HISTORIC AND DESIGN REVIEW COMMISSION

February 15, 2017

HDRC CASE NO: 2017-057
ADDRESS: 401 KING WILLIAM
LEGAL DESCRIPTION: NCB 745 BLK LOT SE IRR 279.44 FT OF 1, 2 & 3
ZONING: R-4 S,HE
CITY COUNCIL DIST.: 1
DISTRICT: King William Historic District
LANDMARK: Norton / Polk / Mathis House
APPLICANT: Orlando Cortinas/Villa Finale
OWNER: National Trust for Historic Preservation
TYPE OF WORK: New handrail
REQUEST:

The applicant is requesting a Certificate of Appropriateness for approval to install a new iron handrail at the front steps of the main structure.

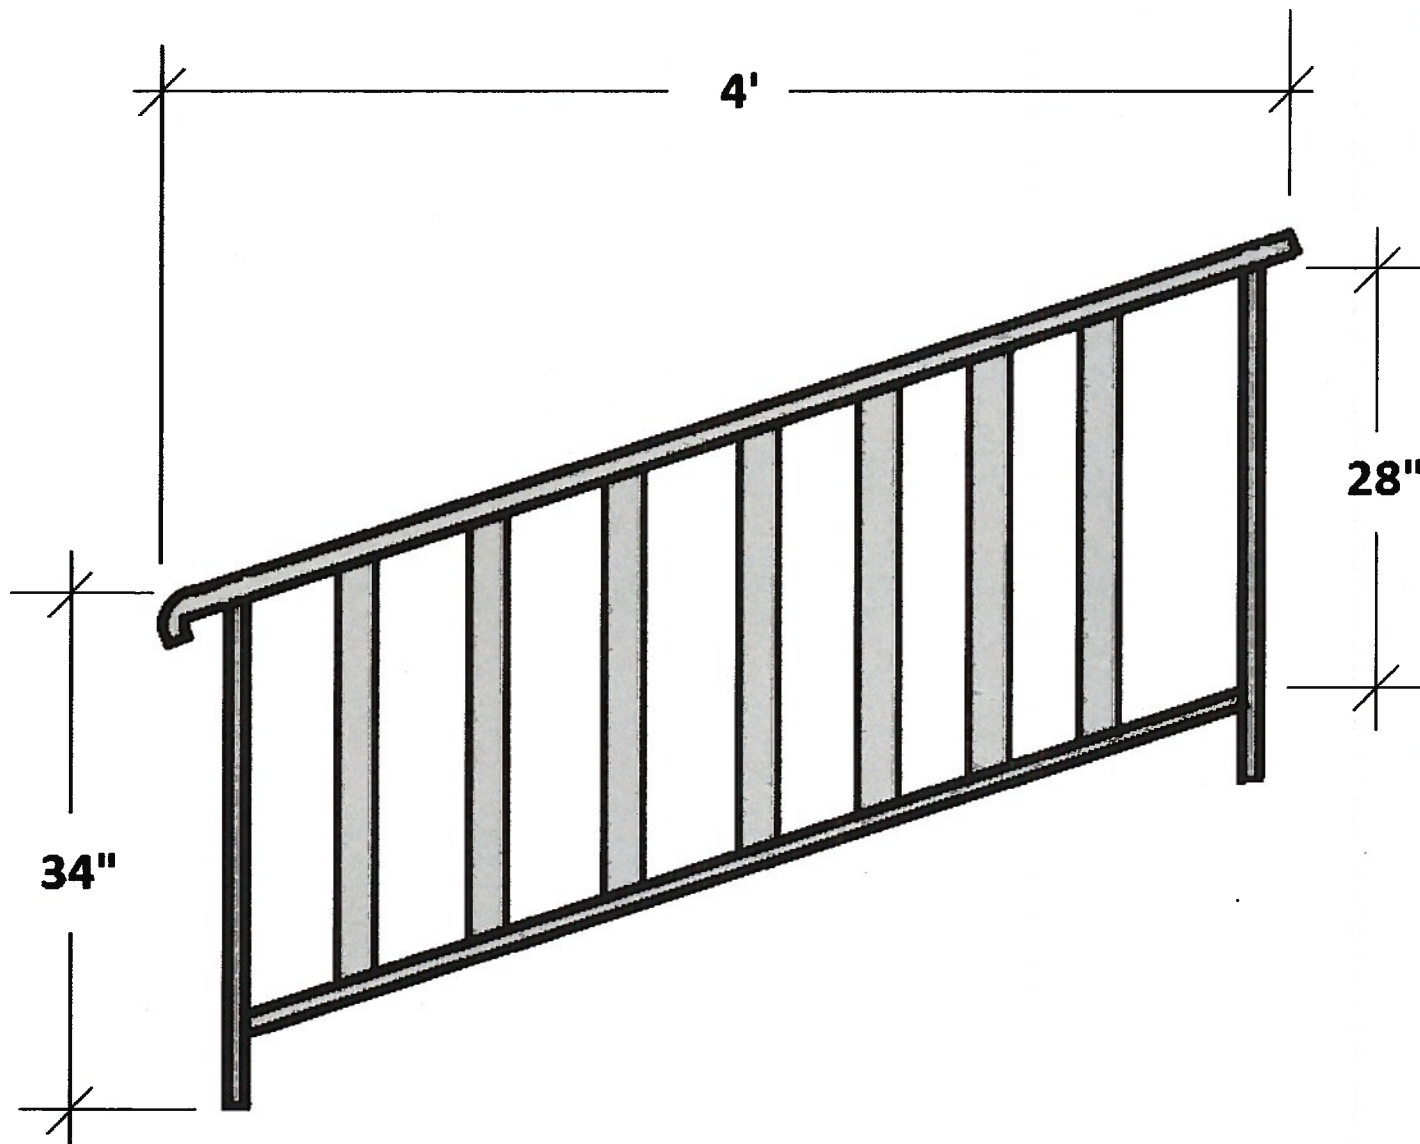
- a. The structure is a two-story Italianate home, built in 1876. It is a contributing structure to the King William Historic District, which was designated in 1968.
- b. There are three front stone steps leading up to the front porch. The proposed wrought iron metal handrail is 34” tall, and 4’ long, and will be on the left and right sides of the front steps. The design of the proposed handrail matches the handrail installed along the rear steps. According to the Guidelines for Exterior Maintenance and Alterations 7.B.iv., add new elements that do not create a false historic appearance, or distract from the historic character of the buildings. Staff finds the proposed handrails appropriate and that they will not negatively impact the historic structure as they are reversible.

Staff recommends approval as submitted based on findings a through b.
